**REGULAR MEETING OF THE
PLANNING AND ZONING COMMISSION
CITY OF HIGHLAND VILLAGE, TEXAS
TUESDAY, MAY 16, 2023, at 7:00 PM
HIGHLAND VILLAGE MUNICIPAL COMPLEX
CITY COUNCIL CHAMBERS**

AGENDA#	3	MEETING DATE:	May 16, 2023
SUBJECT:	Conduct Public Hearing and Consider a request to amend the regulations relating to the use and development of 5.66± acres located in the Shops at Highland Village, Block A, Lot 1, said property being generally located north of F.M. 407 and west of Village Parkway (F.M. 2499), by enacting a Planned Development Overlay District for Presidium Highland Village.		
PREPARED BY:	Abra Nusser, AICP, Planning Practice Lead – Public Sector Services, Peloton Land Solutions

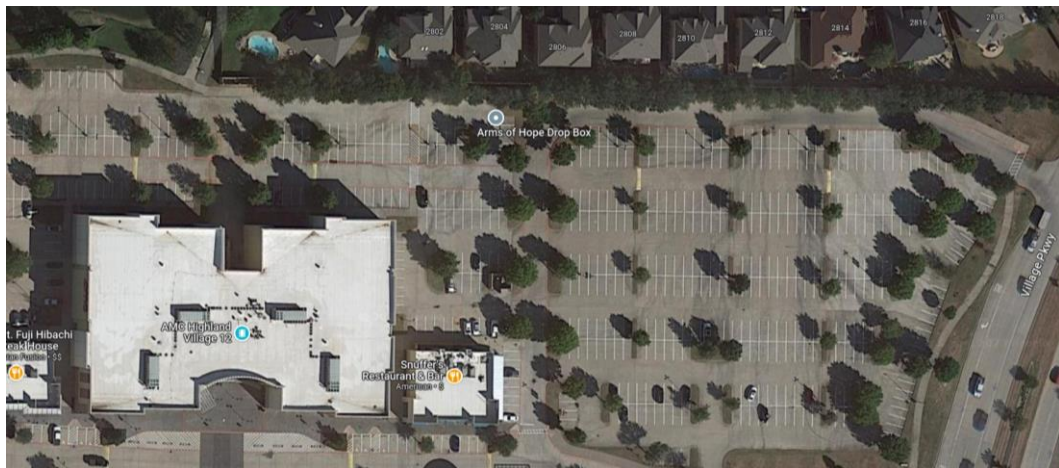
Staff recommended the following graduated setback be provided, at minimum, along the northern property line, to meet the intent of the existing graduated setback requirement in The Shops PD, which did not contemplate a large multi-family structure since multi-family is not a permitted use: *No more than two-stories in height are provided within 150 feet of the residential property line, and no more than three stories in height within 200 feet.*

The proposed building is four stories and 60 feet tall, with approximately 302,000 square feet of floor area. The proposed building does not provide a graduated setback, and the applicant is proposing a straight minimum 80-foot setback along the northern property line. Many of the proposed apartment units will be able to see directly into yards of the homes, as well as into the second stories of the homes and vice versa. Although options for a graduated setback, and a wider landscape buffer and setback along Village Parkway were discussed with the applicant and requested, the applicant did not adjust the proposed location, height, or setbacks of the building. In terms of the siting and massing of the building, modifications would be required from the R District for height, maximum lot coverage, front yard setback, rear yard setback, and landscape buffer along Village Parkway.

To brainstorm alternatives, Staff asked if providing the graduated setback would be possible if the building were five stories instead of four in an effort to improve proposed compatibility along the northern property line. The applicant stated that providing a graduated setback in the building design would result in loss of units, even if more than four stories are provided, and would make the project cost prohibitive. The applicant also stated that a building more than four stories tall could cause cost prohibitive changes to construction type and materials. Information demonstrating the development of these alternatives and their potential impacts on project cost/return have not been provided for review or consideration, and the applicant stated that no building design was explored that had a graduated setback.

The applicant provided sightline exhibits to address the Staff comment regarding views from the north-facing apartments to homes and vice versa (see Attachment 3: Sightline Exhibits). The applicant provided the Exhibits, but they did not resolve the technical sightlines that would be applicable with the proposed design of the upper stories' north-facing units to and from the homes to the north, especially from the existing homes' second stories and vice versa.
